SERVICE BULLETIN

**Subject: Ceronix Overhead Monitors -
AC Power Receptacle - 57-301032-000**

Bulletin No. SB04-6

FIGURE 1

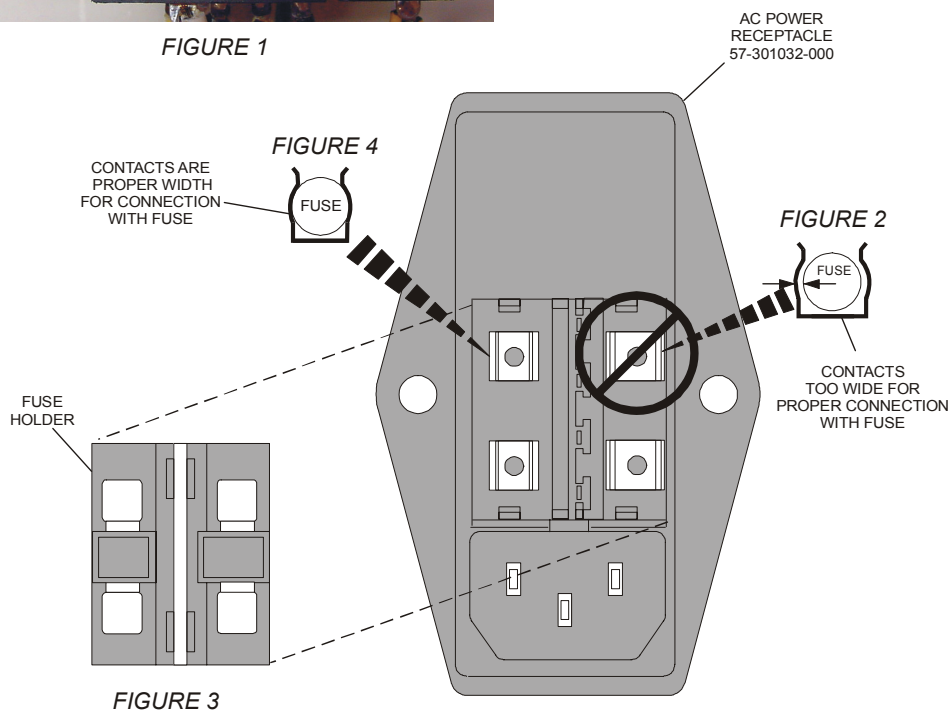
It has come to our attention that the AC power module from Delta Electronics, (refer to Figure 1), is being manufactured with the fuse connector clips spread open too wide for the fuse. Refer to Figure 2.

The failure from this defect is intermittent power loss to the overhead monitors.

1. Remove the power plug from the power module.
2. Remove the fuse holder block. Refer to Figure 3.
3. Squeeze the fuse connector clips together so that they make a solid connection with the fuse. Refer to Figure 4.
